Lake Havasu City Council Work Session Police Facility, 2360 McCulloch Boulevard North Tuesday, May 9, 2017, 5:00 p.m.

5.1 Presentation and Discussion of The Downtown Design Guidelines for the Downtown Corridor - the Areas of Swanson Avenue, McCulloch Boulevard, Mesquite Avenue between Acoma Boulevard and Lake Havasu Avenue - Including Roadways, Hardscape, Landscape, Public Art, Sight Furnishings, Sidewalks, and Lighting in Public Right-of-Way

Lake Havasu Downtown Design Guidelines

PROPOSED STREET SECTION CONCEPTS

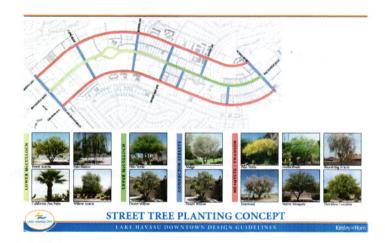
Councilmember Lane stated the proposed design is beautiful but expressed concern that there were no loading and unloading zones for shipping and receiving. Mr. Perillo stated there are currently no loading or unloading zones so that situation would remain the same as it is today. Councilmember Lane stated by taking four to five feet of traffic lane out it may be difficult to get around the trucks and would be mixing that with bicycles. Mr. Perillo stated that they could address that situation by creating some loading zones where there would be no parallel parking during certain times of the day.

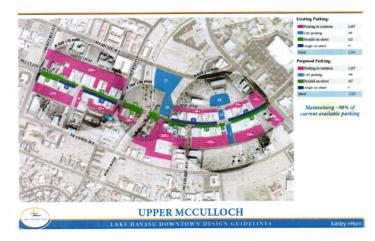
Mr. Perillo stated that they did receive a lot of feedback during the open house and the majority of the attendees were very much in favor of the improvements but the main concern was parking. Mr. Perillo stated they are maintaining 98 percent of the parking and the only thing they are changing with respect to parking and design is they are taking out the angled parking and replacing it with parallel parking. He stated the difference between the two is that there are currently 1,561 parking spots and if the design is implemented there would be 1,525. Mr. Perillo reviewed the proximity of parking to the businesses and how far people have to walk on upper

Mr. Perillo stated that parking behind the buildings can be better organized so they have included overhead power and the dumpsters are organized and inside enclosures. He added the aisles also line up where people travel through to get to the parking.

McCulloch. He said on lower McCulloch by the big box stores they looked at the size of the parking lots and the distance people have to walk to the businesses and said it is comparable to the walking distance on upper McCulloch. Mr. Perillo stated the other thing that was brought up was covered parking and said some of the folks thought covered parking would entice people to use those parking areas more often. Mr. Perillo presented a video showing the proposed improvements.
